**RE: TRIPOLI WAY STAGE 1 EXTENSION
AVIATION IMPACT STATEMENT**

REHBEIN Airport Consulting has reviewed the Tripoli Way Extension - 80% Complete Concept Design prepared by Cardno (6 May 2020) against the relevant National Airports Safeguarding Framework (NASF) Guidelines. The design information was provided in PDF format as follows:

Project:
**TRIPOLI WAY EXTENSION
 AVIATION ASSESSMENT**

Figure No:		B16262/B	
Scale:		1:20,000	
Rev	Date	File Ref:	B16262
0	19 06 20		
			A3 Sheet Size

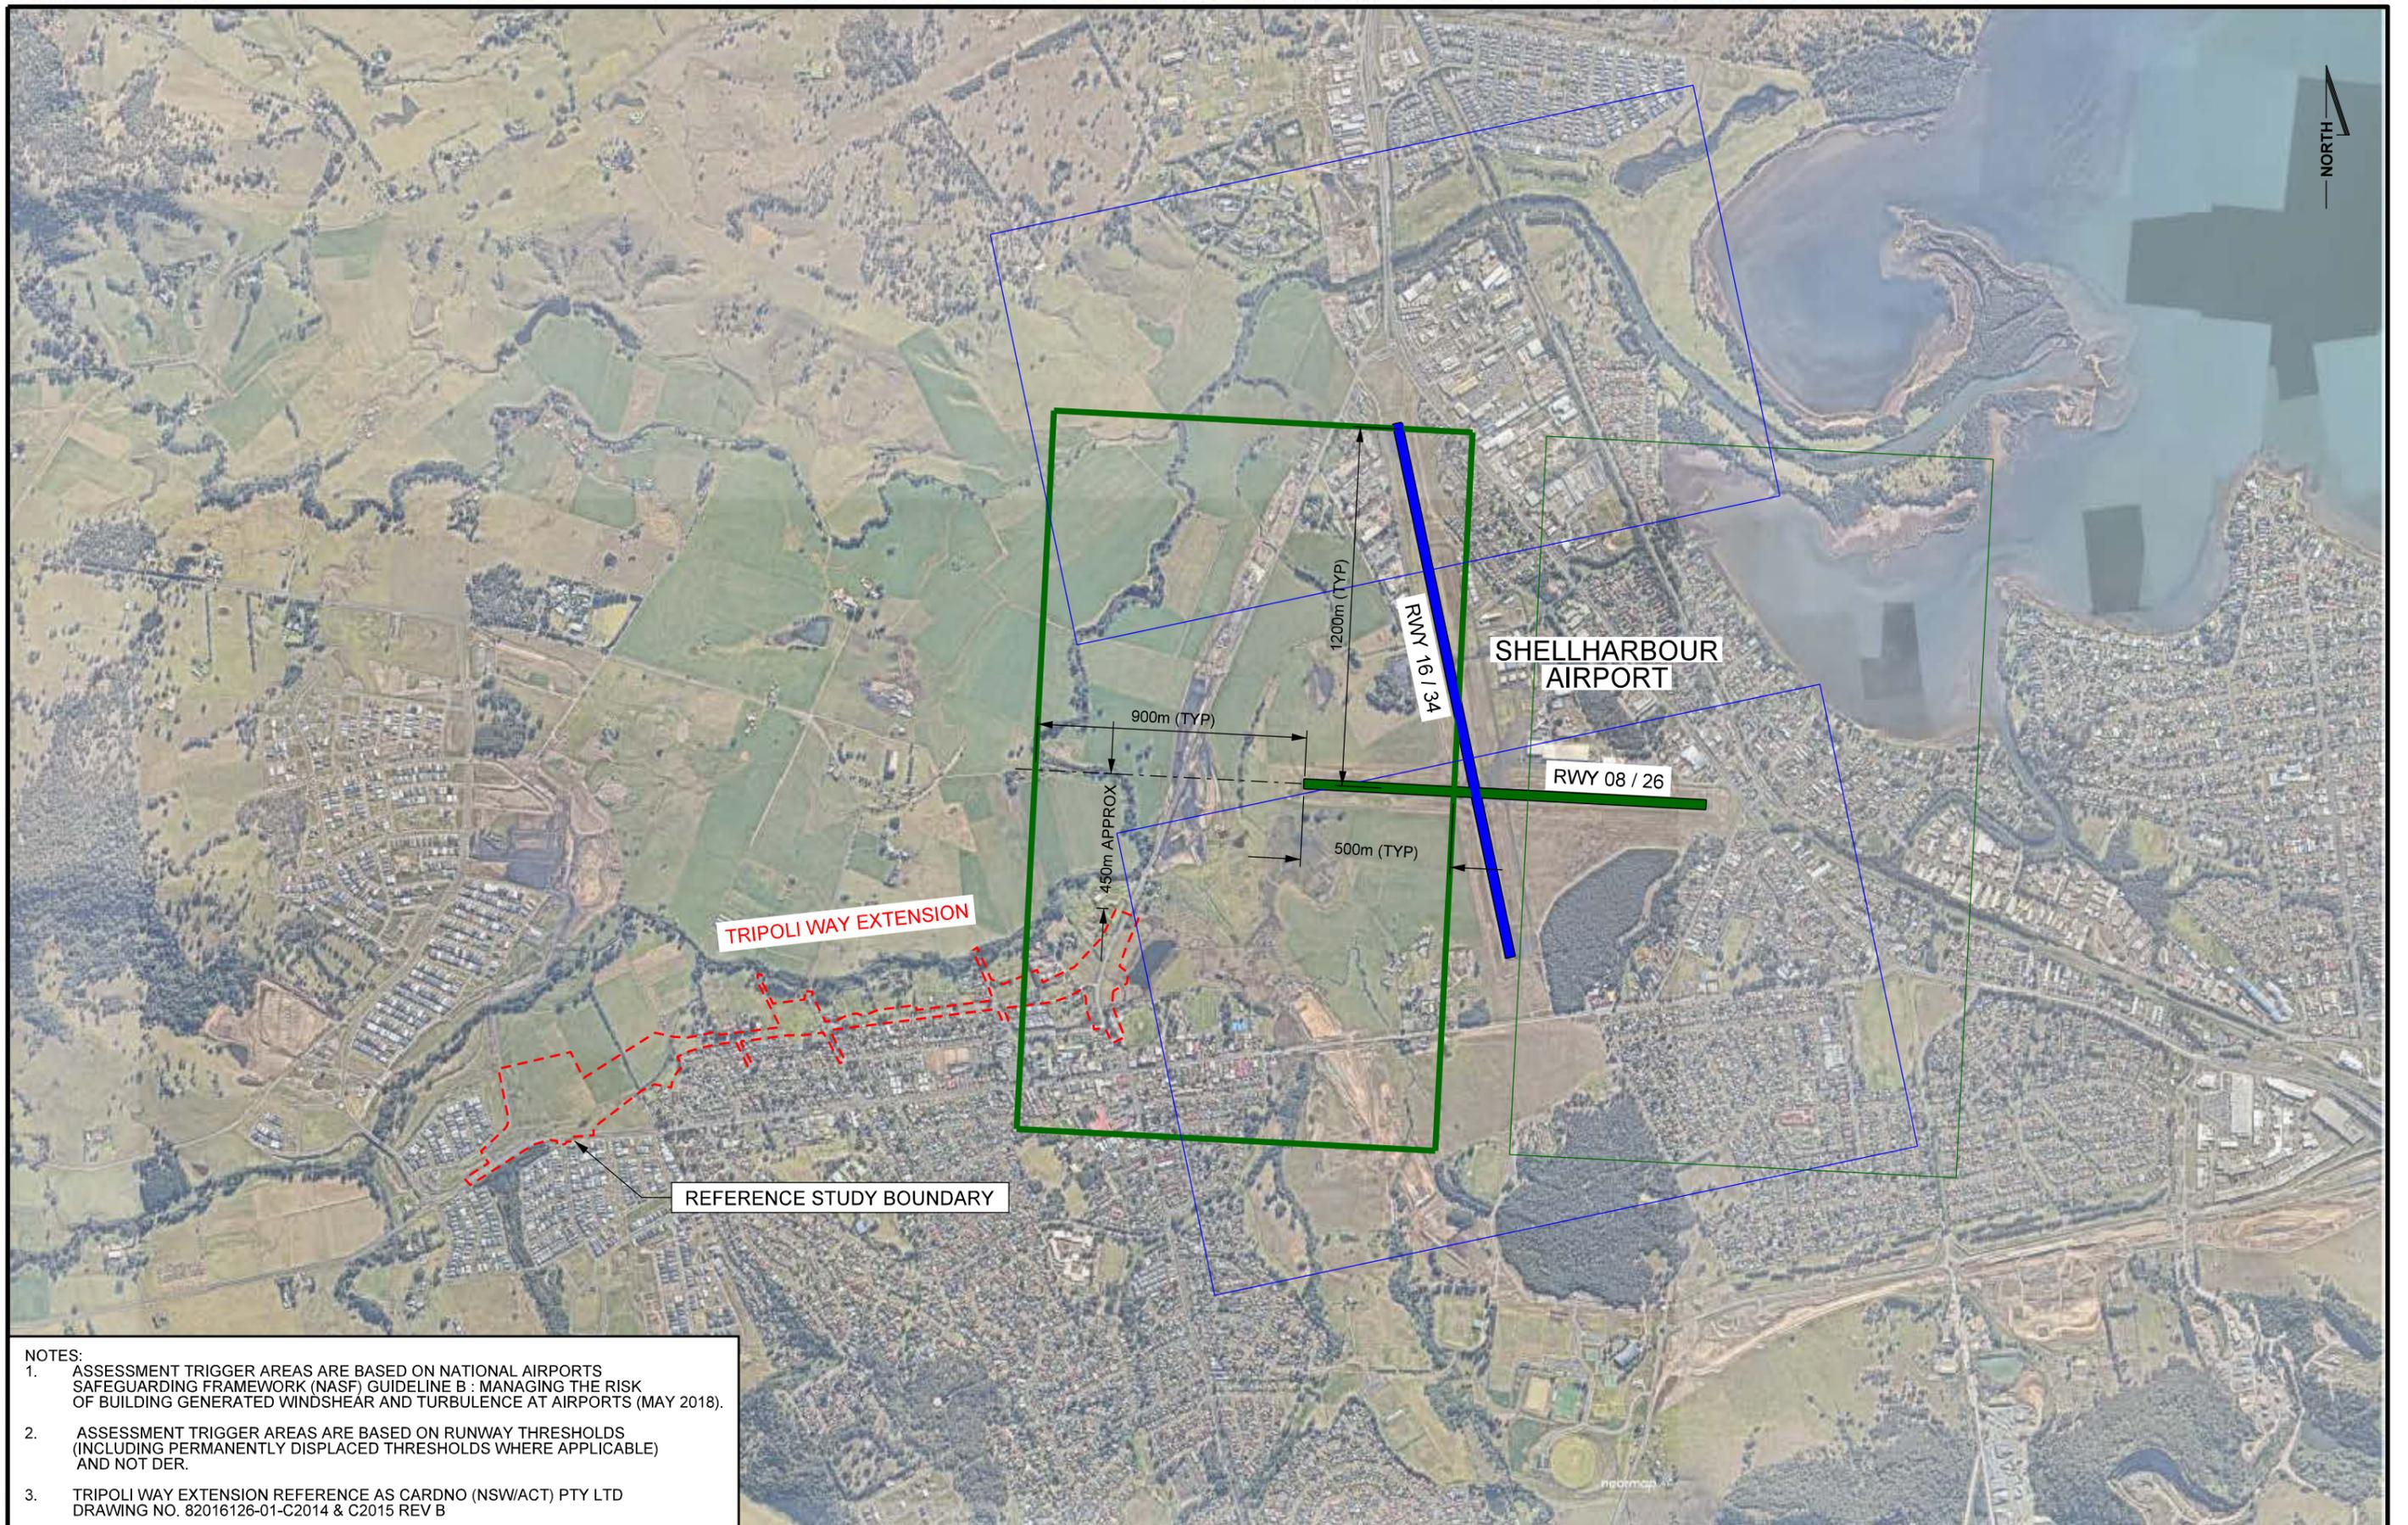
The easternmost section of the Tripoli Way Extension alignment is within the assessment trigger area for the Shellharbour Airport Runway 08/26 as illustrated on **Figure B16262/B**. At the closest point the road extension is approximately 450 m from the extended Runway 08/26 centreline.

Where a proposed development is within the assessment trigger area, the next step is to consider the height of the building to determine its acceptability. The rule is that buildings should not penetrate a 1:35 surface sloping upwards in the direction perpendicular to the runway centreline. Applying the 1:35 surface, building-like structures should not exceed 13 m in height within the assessment trigger area.

Providing such building-like structures are not included and located in the assessment trigger area in excess of 13 m in height, no further reference is required as per Guideline B.

Figure No
B16262/E1

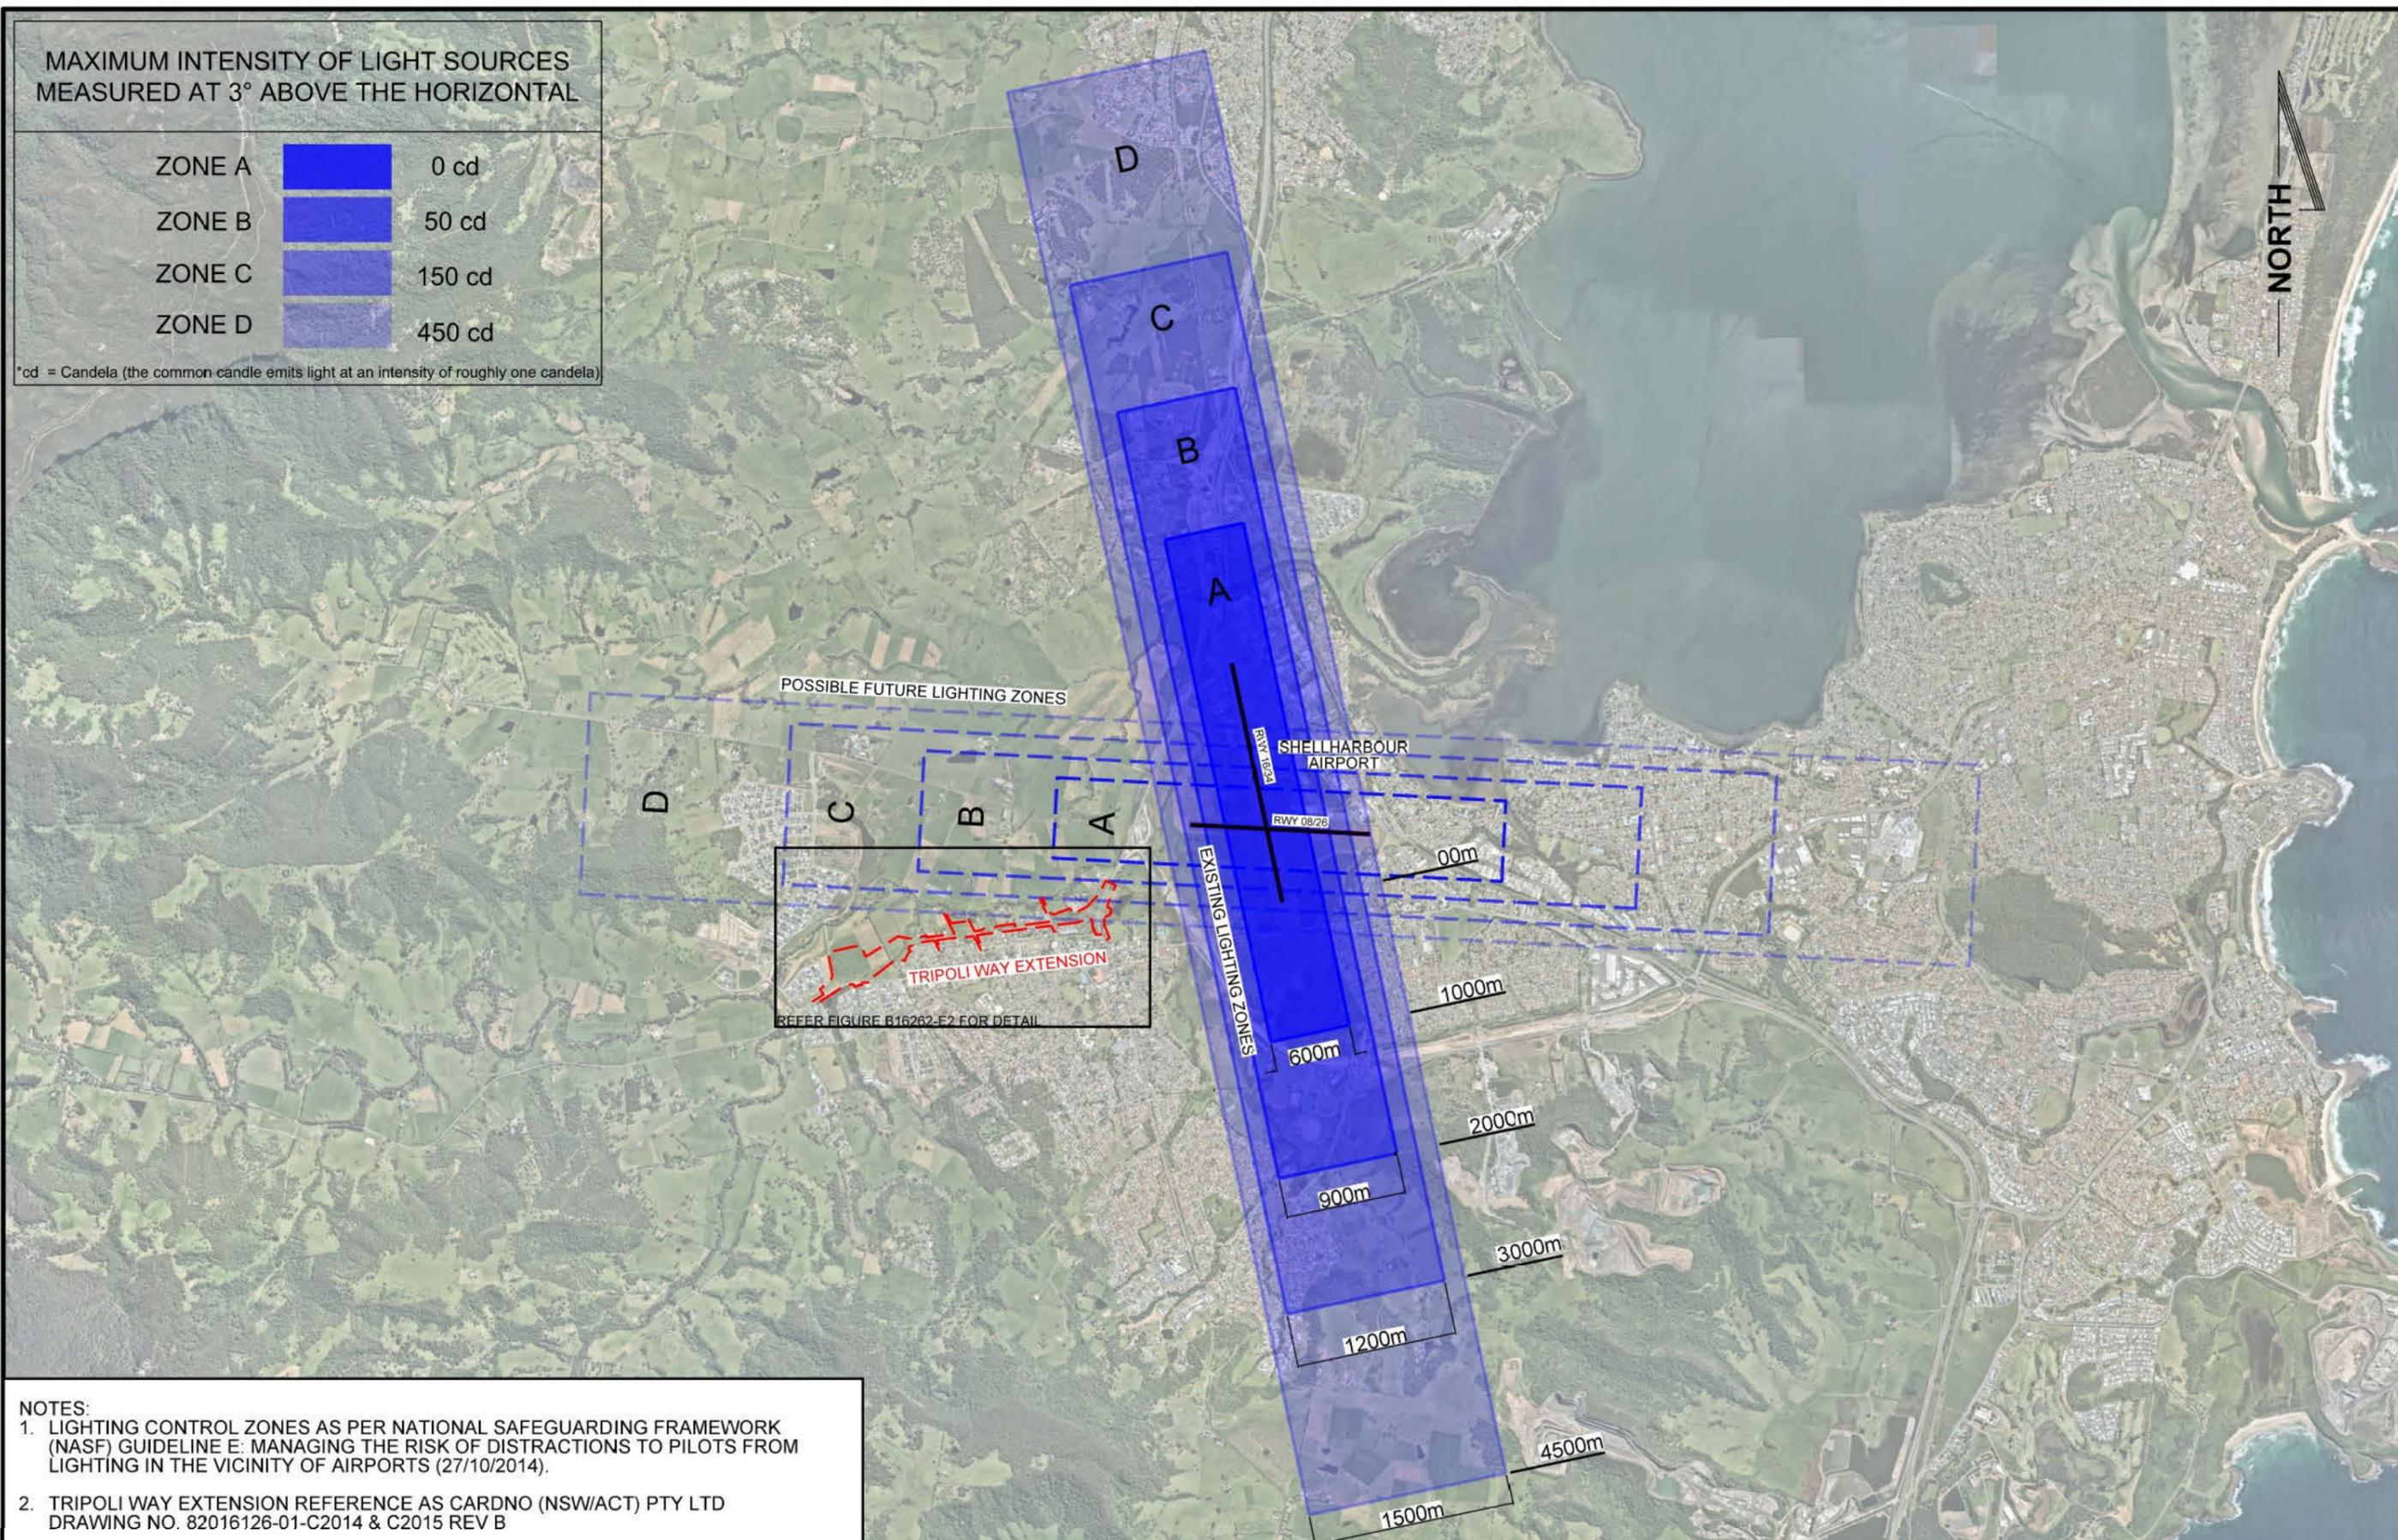
The Tripoli Way Extension is outside the lateral extents of the Runway 16/34 existing light control zones as illustrated on **Figure B16262/E1**.
